**Proposed Material Alterations
to the
Draft Piltown Local Area Plan 2010**

*Kilkenny County Council
Forward Planning*

15th November 2010

Map 1

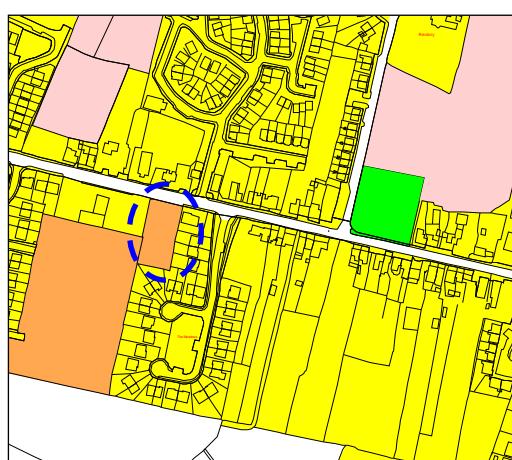
Change zoning of a small area of land, between Nick Falvey and Sons Garage and The Meadows fronting onto the Main Street, from Residential to ‘Existing and General Development’.
